Project TRAFFIC SIGNALIZATION @ N. I-235 AND MERIDIAN INTERCHANGES

Project Number 472.84424 (706956) * SOUTH INTERSECTION *

CITY OF WICHITA

MISCELLANEOUS INFORMATION

Sketches, etc.

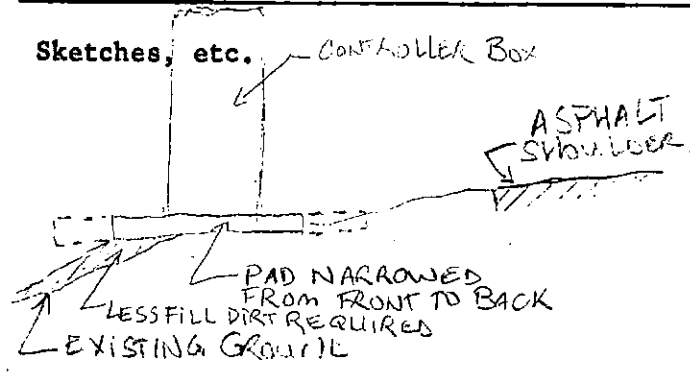
2) TRAFFIC CONTROLLER PAD MODIFIED TO BETTER SUIT SITE CONDITIONS
(SEE BACK)

Sketches, etc.

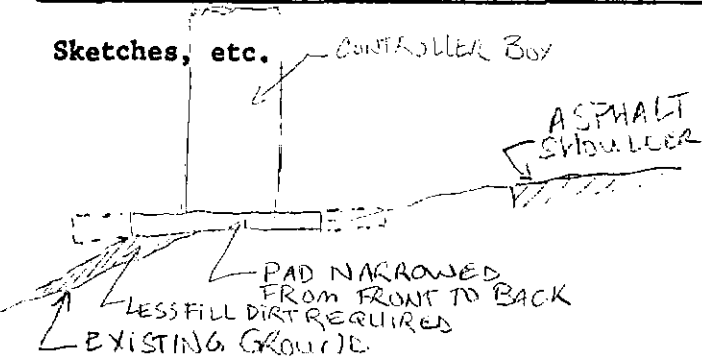
2.) TRAFFIC CONTROLLER PAD MODIFIED TO BETTER SUIT SITE CONDITIONS
(SEE BACK)

PAD NARROWED
FROM FRONT TO BACK

LESS FILL DIRT REQUIRED
